RE: MEDINA COUNTY
GRANGER TOWNSHIP
GRANGER UNITED METHODIST CHURCH
(PERMIT NO. 3PR00594)

On August 8, 2013, this writer conducted a compliance evaluation inspection (CEI) on the wastewater treatment plant (WWTP) serving the Granger United Methodist Church. The Granger United Methodist Church is located at 1235 Granger Road, Granger Township, Medina County.

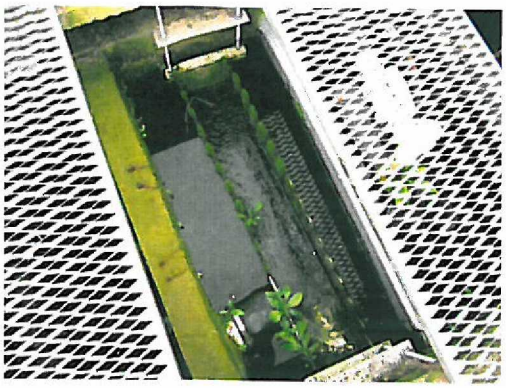
5) Contents of the settling tank were clear down to a depth of approximately 6", but did contain some floating scum and duckweed on the water surface. The settling tank effluent trough contained a deposition of solids; and there was a mossy

growth on the weirs of the trough and a few plants (see photo).

The effluent trough should be kept clean at all times, and the skimmer operational.
